AGENDA
PLANNING & ZONING COMMISSION
THURSDAY, December 10, 2020
7:00 P.M. Virtual Meeting *

Planning Commission Memorandum

TITLE: Carbondale Center Place – Major Site Plan Review, Subdivision Exemption, Conditional Use Permits and Alternative Compliance

2 NORTH BUILDING - LEVEL 1 PLAN
3/32" = 1'-0"

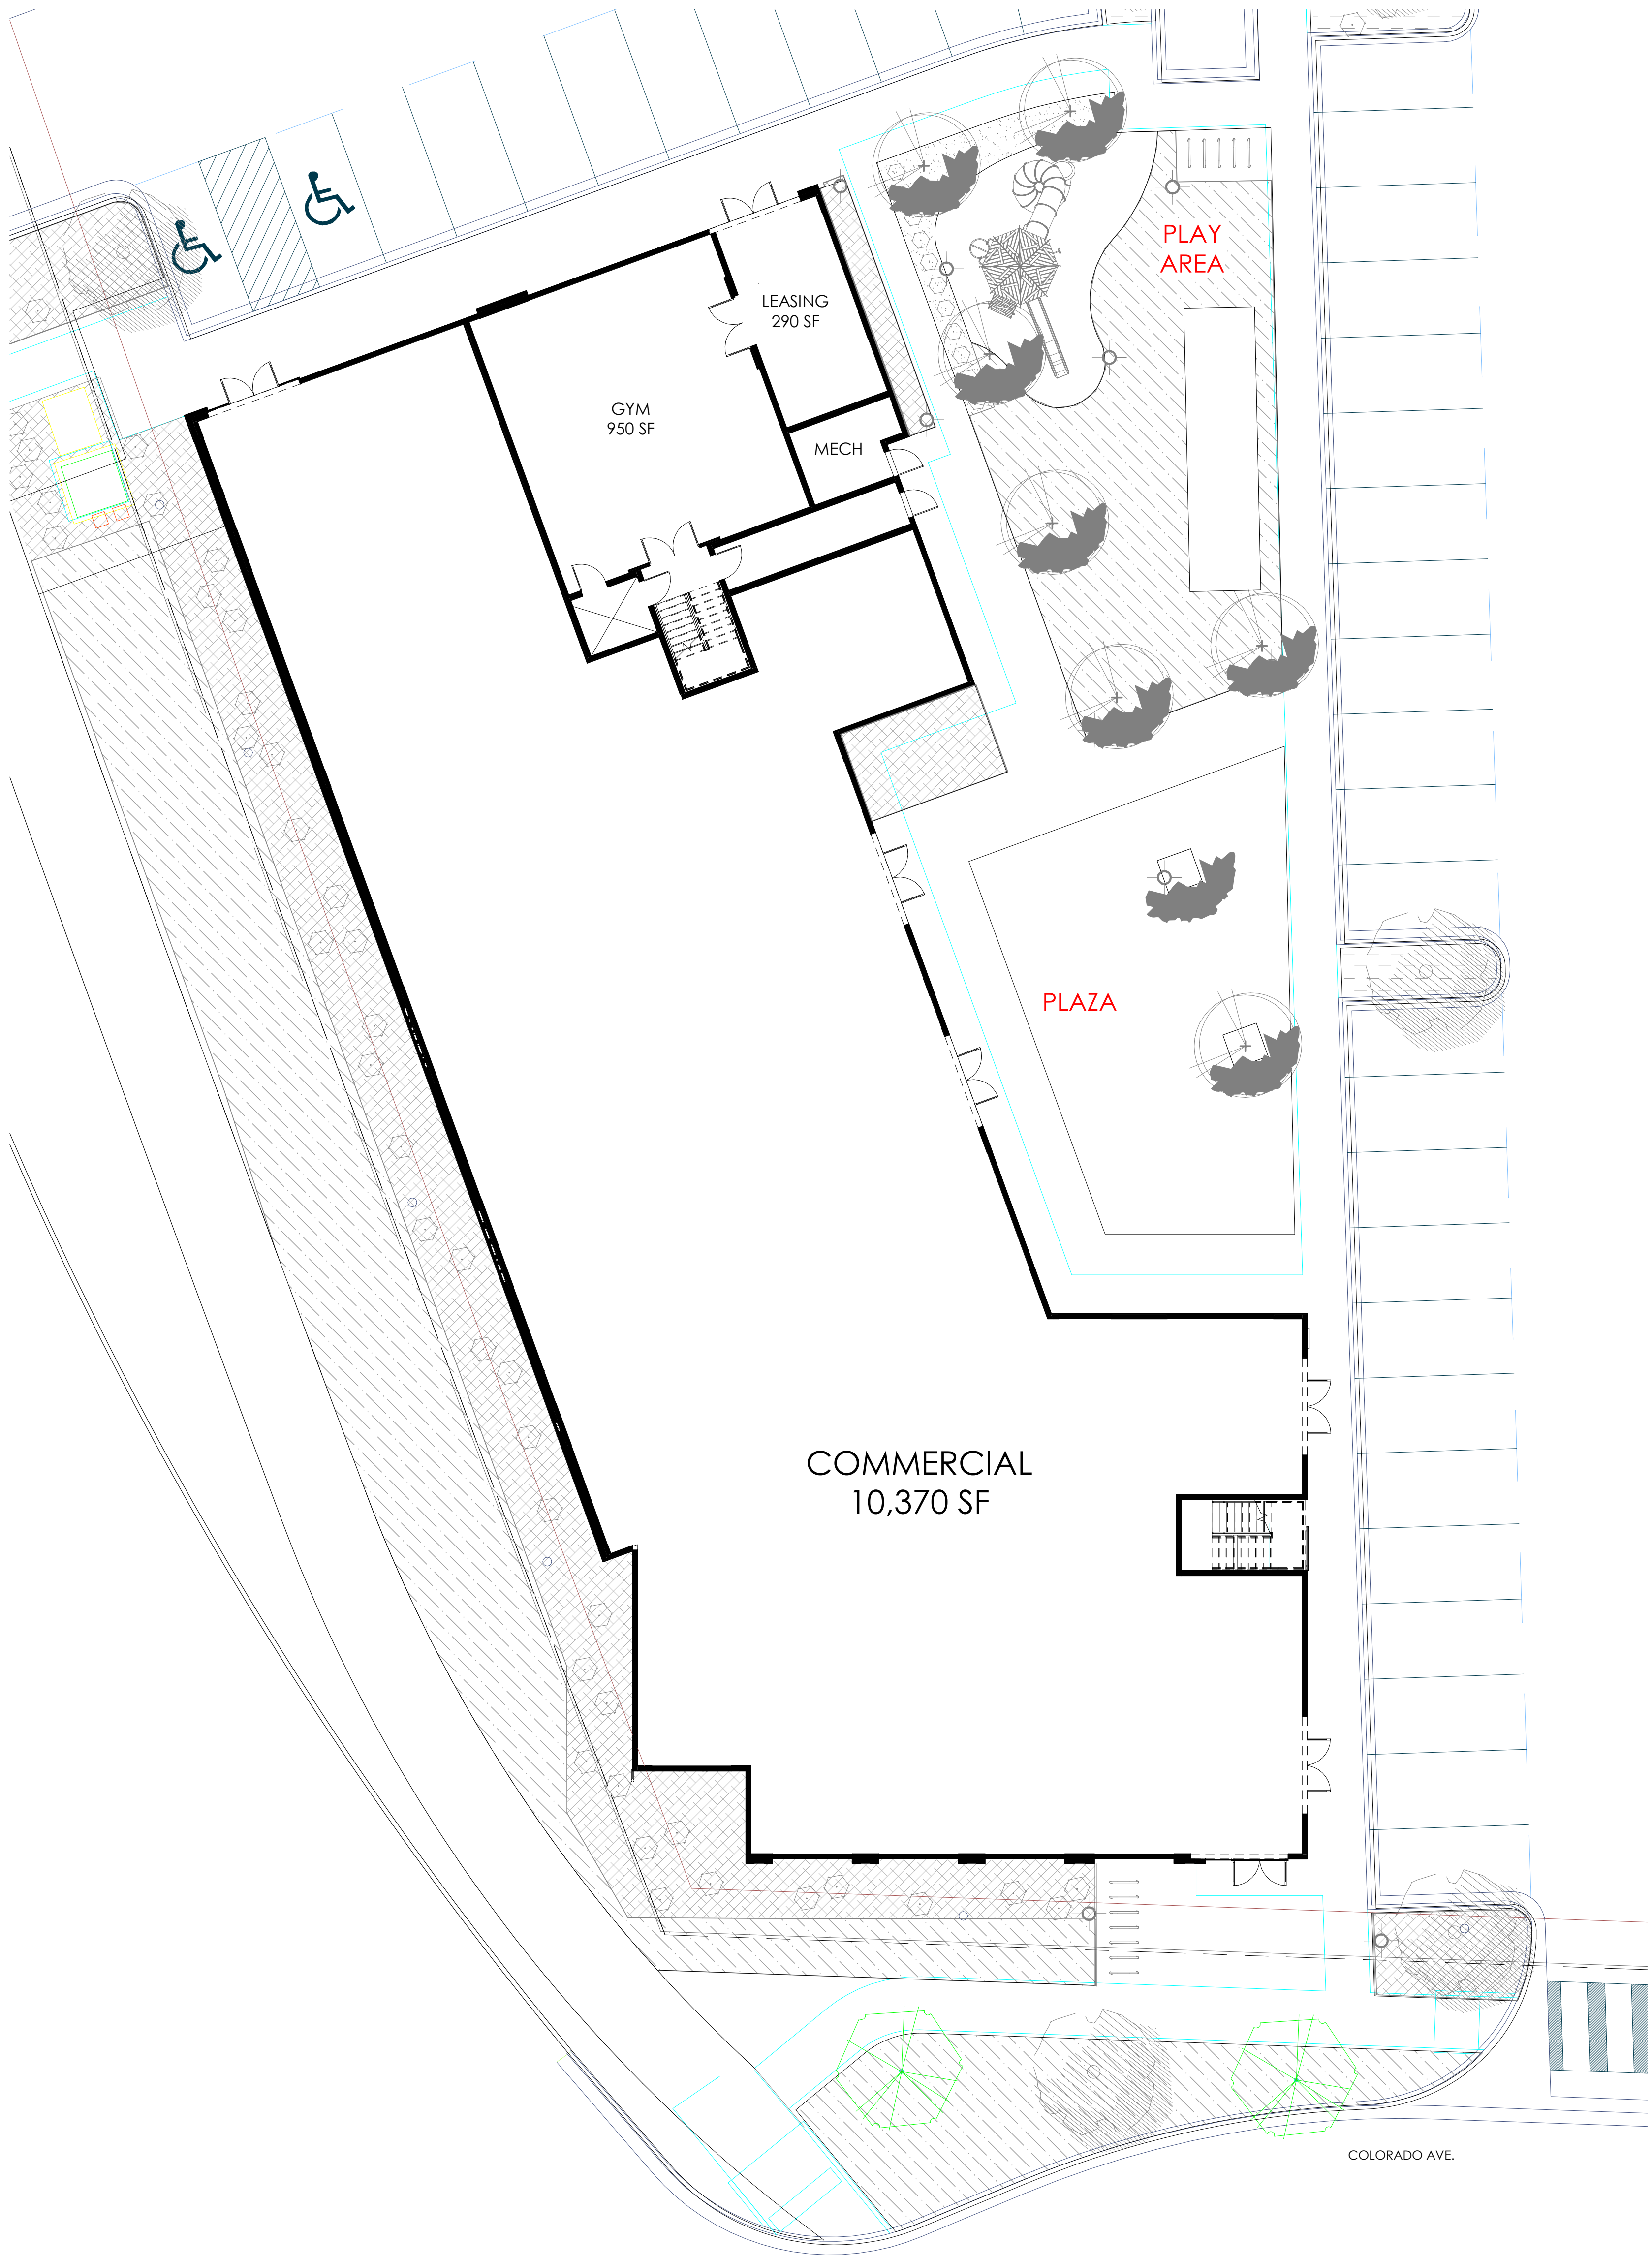
This section requires private outdoor space and bulk storage. Sheet P6.1 in Exhibit H clearly shows the location and size of both the private outdoor and bulk storage spaces. Staff has not run the numbers to be sure the areas are in compliance but that will be done prior to the next meeting.

WEST ELEVATION

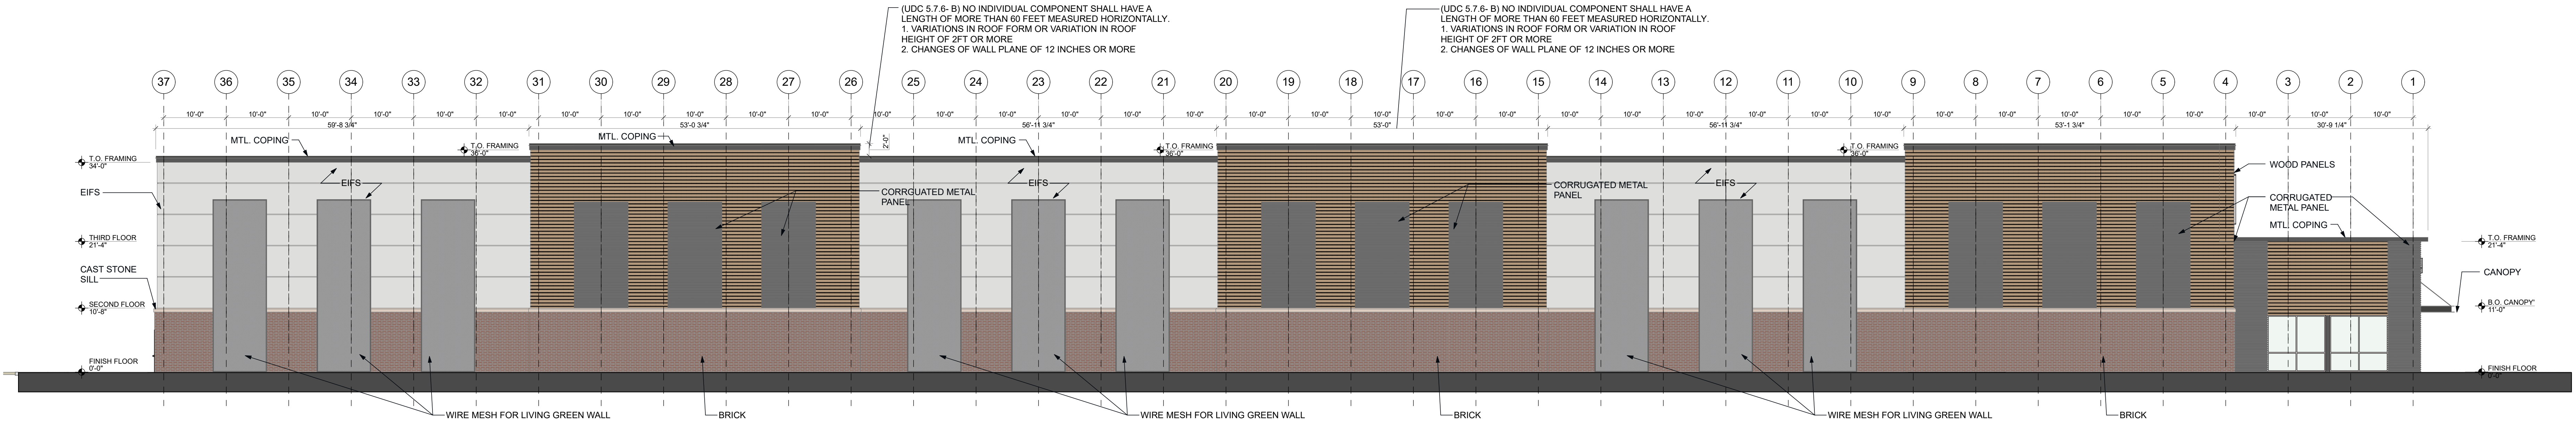
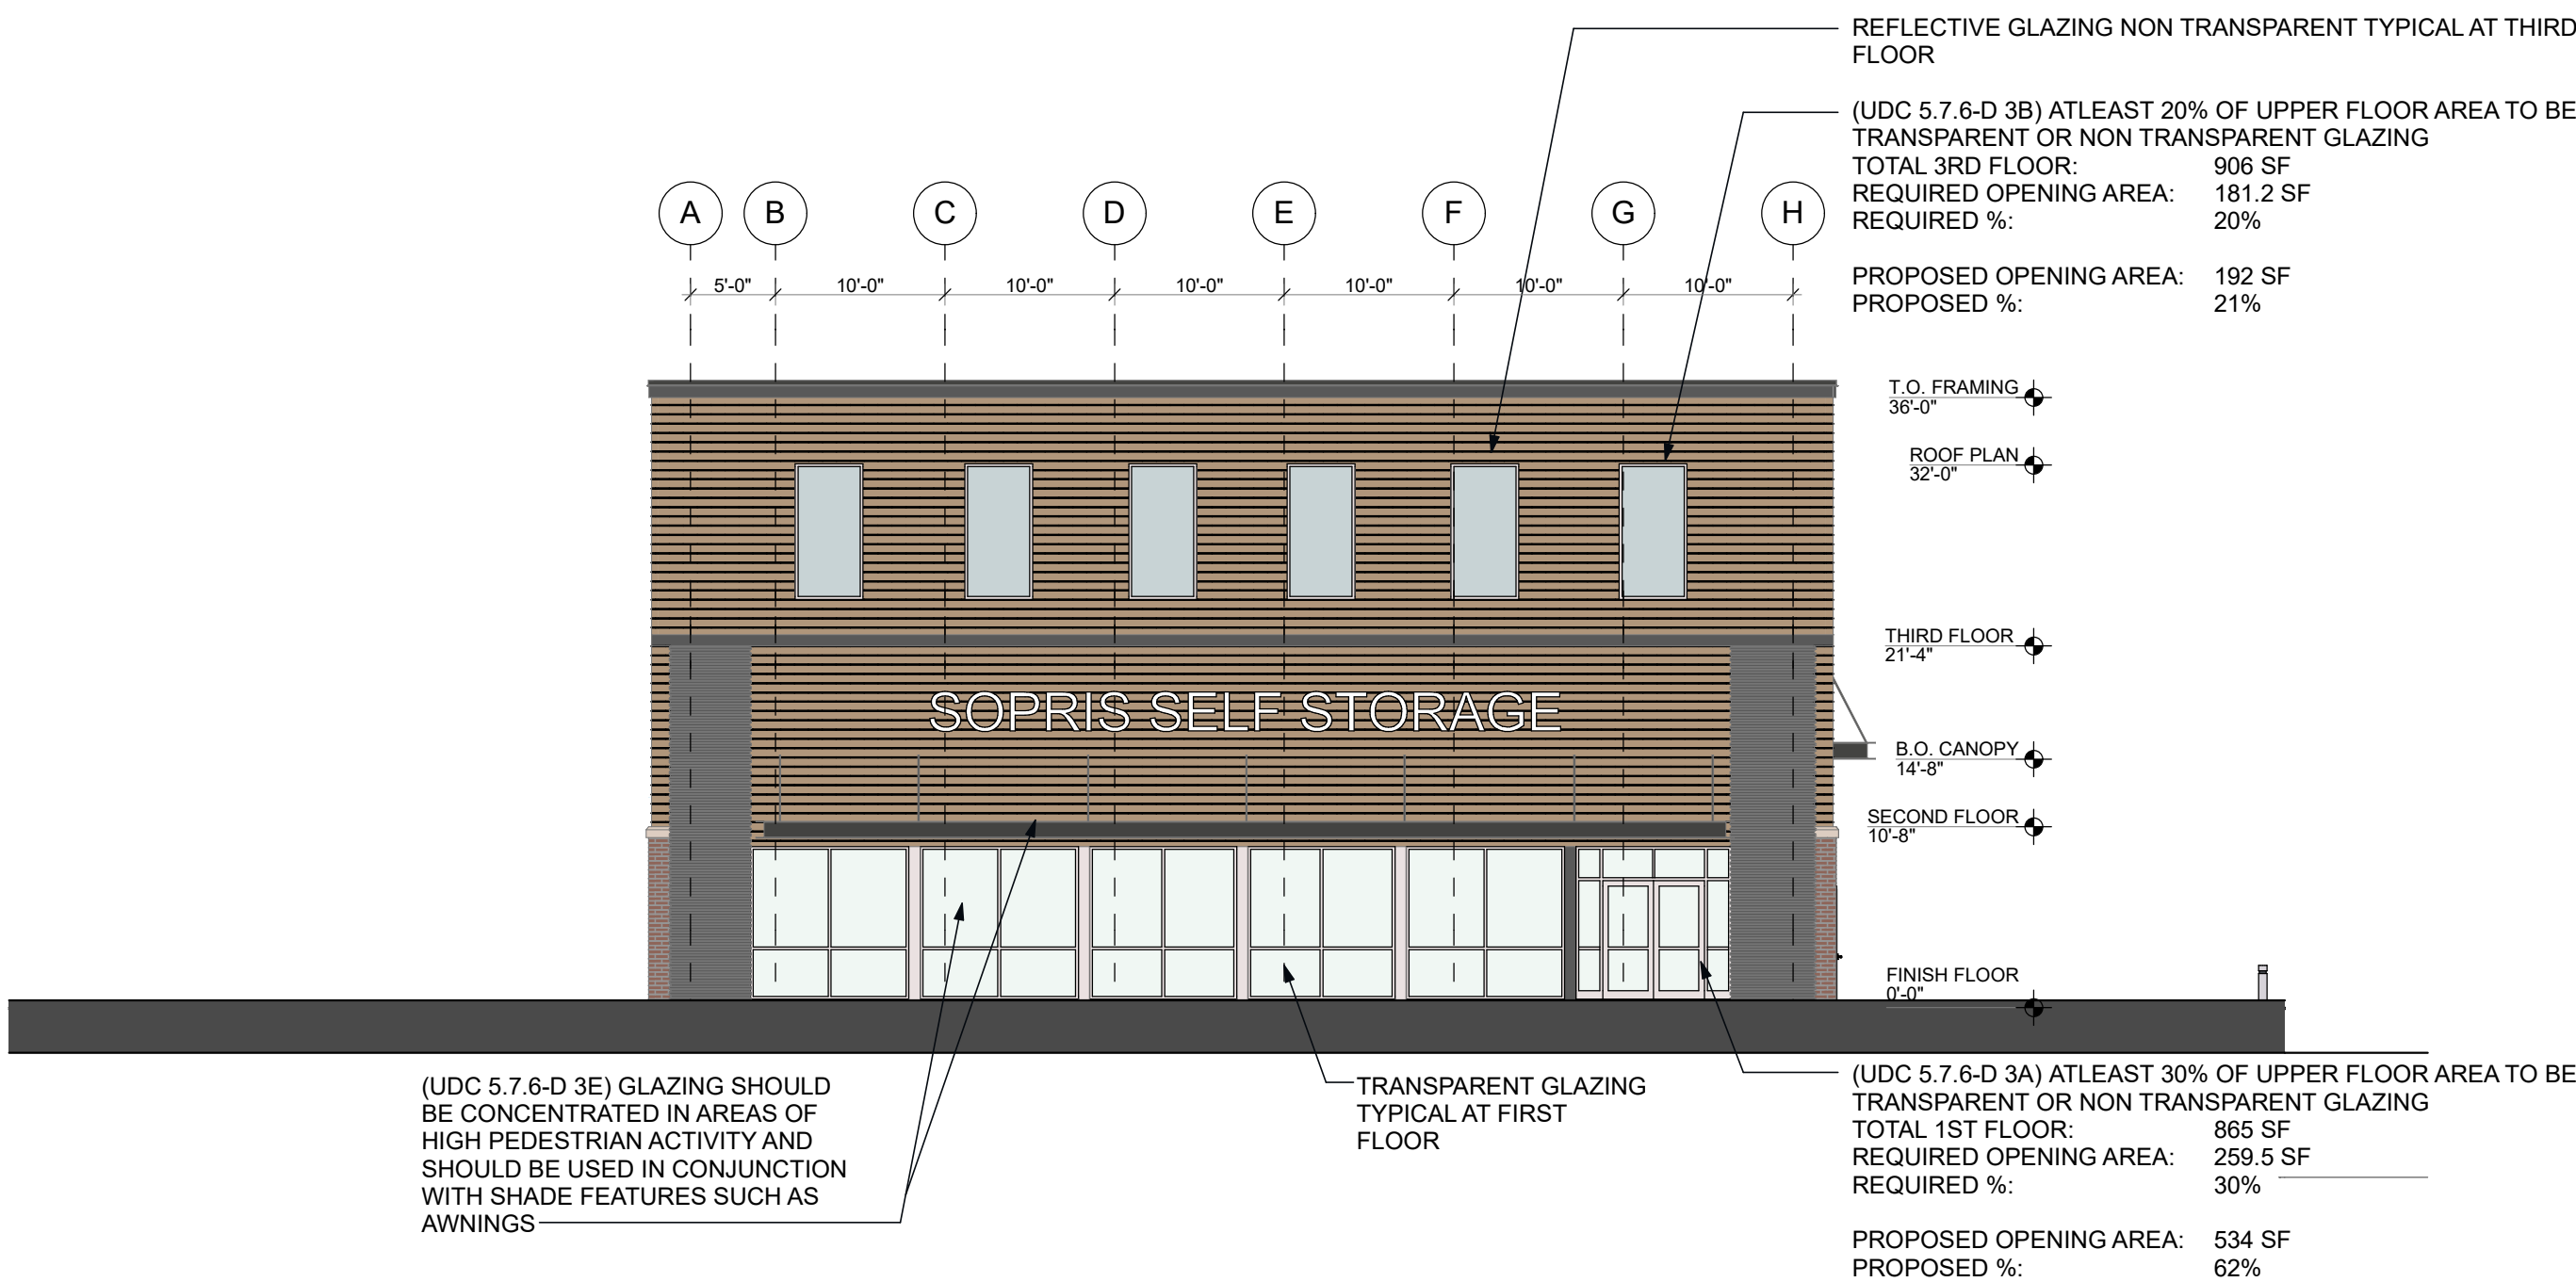
Sheet SCH-103 in Exhibit O clearly shows compliance with this section. It creates 10 foot long segments with the variation of the required 2 feet in height shown. These changes are emphasized by use of a different material. Sheet SCH-101 shows the changes in the wall planes.

There is a clearly identifiable base, body and top of building. This is clearly shown to be in compliance on Sheet SCH-103.
